Field Safety Notice

Device name: CoverStainer Slide Rack
Device number: CS10330
Date: November 13th 2012

Device Brand name: CoverStainer Slide Rack
Item No: CS10330

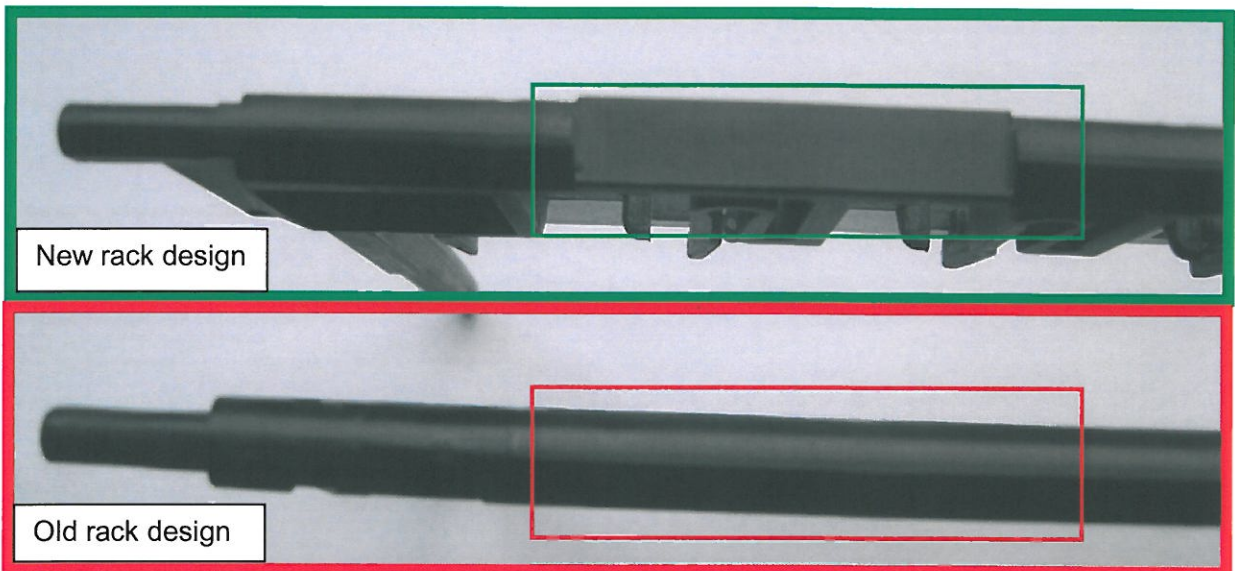
This Field Safety Notice has been initiated because the expected life time of the CoverStainer slide racks (CS 10330) does not meet established performance requirements, originating from variations in the manufacturing process. The result can be that slides are falling out of the rack during the staining process. While this has been observed at only a few customer sites, the corrective action includes all CoverStainer installations.

Dako has chosen to correct the rack situation by using a new manufacturer and has improved the rack design to secure correct slide position in the rack.

The new rack design has visible changes which makes it easy to distinguish from the old rack design. The images below show a barcode surface which is present on the new rack (green) but not on the old rack (red).

Dako therefore recommends that further use of the CoverStainer slide rack should cease and be discarded immediately upon receipt of the new racks. New racks will be shipped free of charge to you immediately after this letter has been sent.
